Access Compliance Report

Public Rights-of-Way

(Curb Ramps)

Intersection ID: 47616	Main Street: TWISTED_PINE_DR	Cross Street: CANIPE_DR	Location: E
ADA ID: 1C085677EAE7	Ramp Type: Perp	Initial Pass/Fail: Fail	Overall Compliance: No
			Severity Score: 21.25

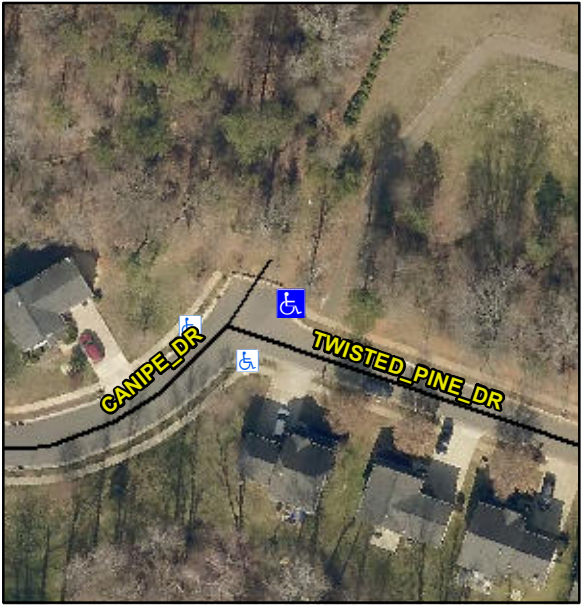
Codes/Mitigation Info/Possible Solution		Field Measurements/Component Compliance					
	Possible Solutions:						
	Remove & Replace Entire Ramp.	N/A	Ramp Length (in)	48.5	Yes	Ramp Slope (%)	5.3
		No	Ramp Width (in)	47.5	No	Ramp XSlope (%)	6.8
		N/A	Flare Type LT	N/A	N/A	Flare Type RT	N/A
		N/A	Flare Slope LT (%)	N/A	N/A	Flare Slope RT (%)	N/A
		N/A	Flare Traversable LT?	N/A	N/A	Flare Traversable RT?	N/A
		N/A	Landing Length (in)	N/A	N/A	DWS Provided?	N/A
		N/A	Landing Width (in)	N/A	N/A	DWS Contrast?	N/A
		N/A	Landing Slope (%)	N/A	N/A	DWS Length (in)	N/A
		N/A	Landing X Slope (%)	N/A	N/A	DWS Full Width?	N/A
		N/A	Landing Curb? (Y/N)	N/A	N/A	DWS Offset (in)	N/A
		N/A	Shared Landing?	N/A			
		N/A	Gutter Ponding?	N/A	N/A	Gutter Slope (%)	N/A
		N/A	Gutter Lip Ht (in)	N/A	N/A	Gutter X Slope (%)	N/A
		N/A	Painted X Walk1?	No	N/A	Painted X Walk2?	N/A
			X Walk 1 Direction	To SW		X Walk 2 Direction	N/A
		N/A	X Walk 1 Width (in)	N/A	N/A	X Walk 2 Width (in)	N/A

X Walk 1 Slope (%)	5.0		X Walk 2 Slope (%)	N/A
			X Walk 1 X Slope (%)	4.8		X Walk 2 X Slope (%)	N/A
		N/A	Ramp inside XWalk1?	N/A	N/A	Ramp inside XWalk2?	N/A
<p>Surveyor Notes:</p> <p>N/A</p> <p>PROW/ADA:</p> <p>Not Found, R304.5.1, R304.5.3</p>							
			Road Slope (%)	N/A	N/A	Clear Space?	N/A
			Road X Slope (%)	N/A	N/A	Clear Space to XWalk (in)	N/A
		N/A	Any Obstructions?	N/A	N/A	Storm Grate/Utility Hazard?	N/A
			Obstruction Type			Storm Grate/Utility Type	
					N/A		N/A
					Yes	Surface Condition? (G/P)	Good
